Docket Items # 8 & 9 BAR CASE # 2014-00065 & 2014-00066 BAR Meeting April 2, 2014

ISSUE:	Request for Partial Demolition and alterations
APPLICANT:	200 NR LLC, by Patrick Camus, Studio Camus
LOCATION:	405 Cameron Street
ZONE:	CD / Commercial Downtown

# BAR2014-0065 & 0066

# French Quarter Light

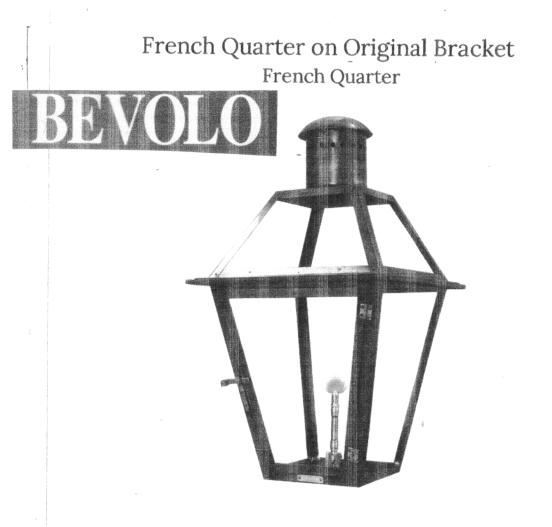
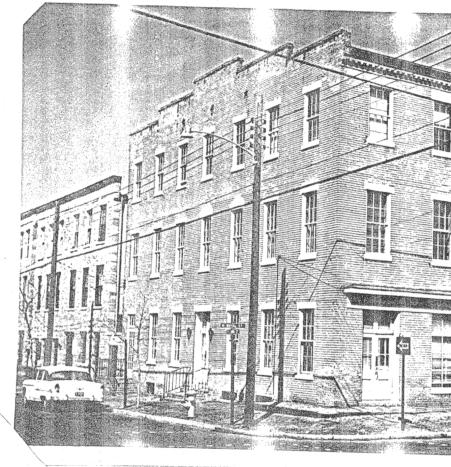
- 1. The existing granite curb be preserved in situ on the east and south elevation;
- 2. The rooftop units be painted a light gray color to match the sky; and,
- 3. The existing globe light fixtures be retained or replaced with a similar style.

EXISTING EXTERIOR SOUTH & EAST ELEVATIONS WITH PROPOSED DEMOLITION

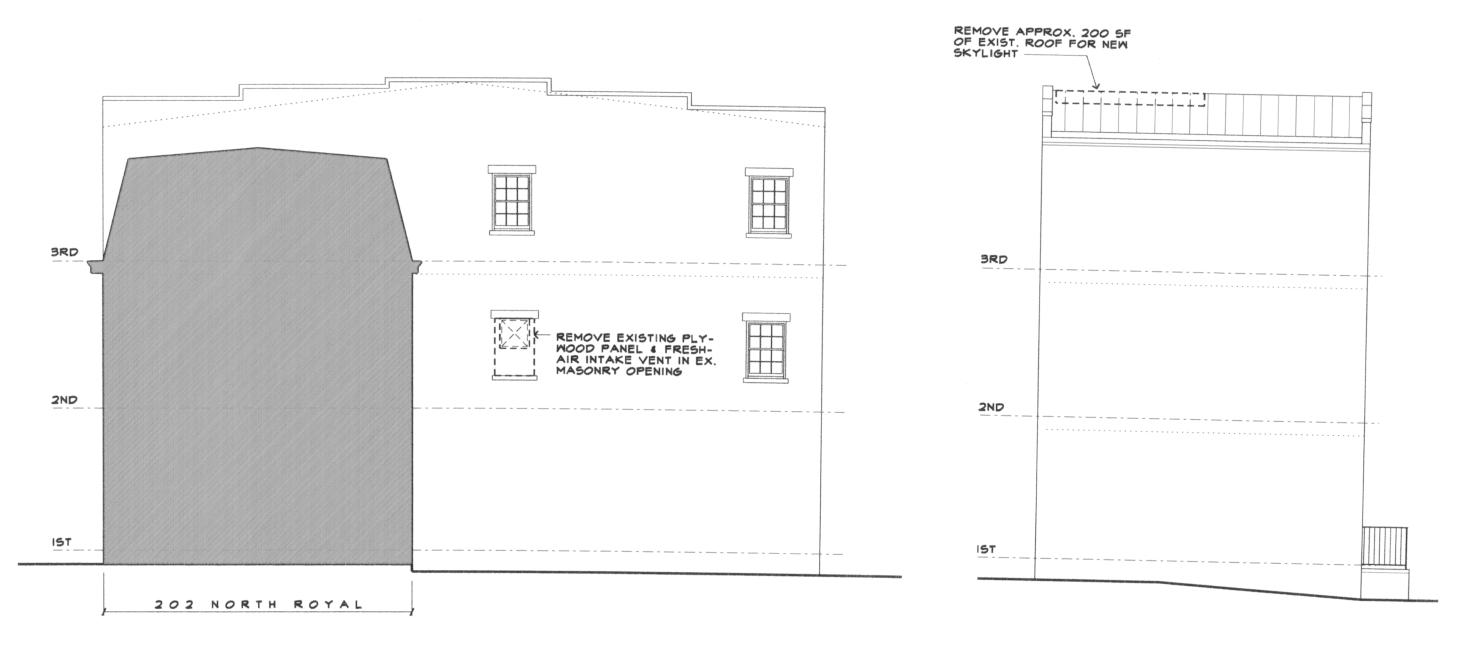
The applicant has worked extensively with staff and provided access to the interior several times, in particular to examine the framing of the storefront window. Staff confirmed on site that there is physical evidence proving the storefront window was a later addition that replaced two smaller window openings that aligned with the windows above. The construction and materials of the storefront window and cornice are of a mid-20<sup>th</sup> century construction. The storefront window was installed prior to March 1959, based on a photograph taken by Russell Jones for Ethelyn Cox's survey. Based on the 1959 photograph, it can also be determined that the globe light fixtures are not original to the building.

Lynnette 703 989 3777 Patrick 703 626 1984 PROPOSED EXTERIOR SOUTH & EAST ELEVATIONS

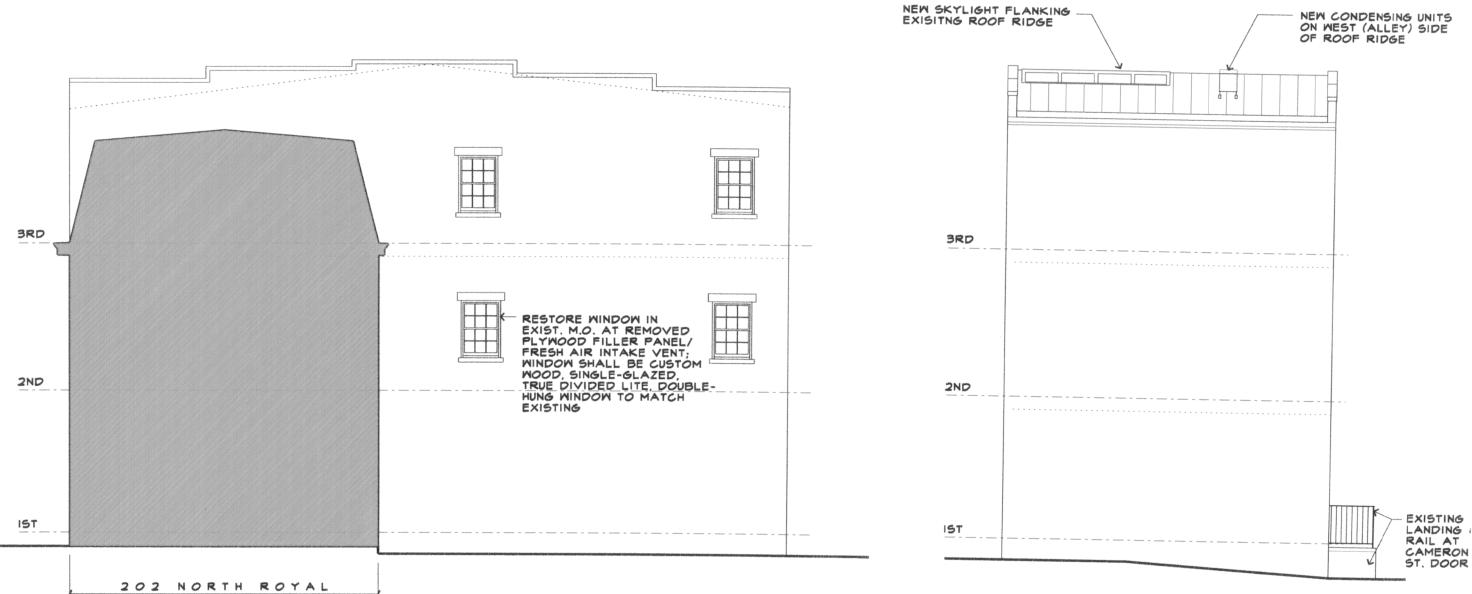
The proposed wood, true-divided light windows comply with the *BAR Window Policy*. The stoop, accessibility ramp, and rail are simple in design and generally meet the criteria of the *Design Guidelines*. While exterior light fixtures do not often appear in period photographs on commercial buildings in 1870, staff suggests that the existing cast iron base and white globe light fixtures may be more appropriate to that period than the Bevolo French Quarter model gas lantern proposed by the applicant. Although a case can be made that this building dates to a transitional period between gas and electrical lights, Staff recommends that the existing globe light fixtures be retained or replaced with a similar period style electric lantern. Staff supports the remainder of the proposed alterations with the condition that the existing granite curb be preserved in situ.
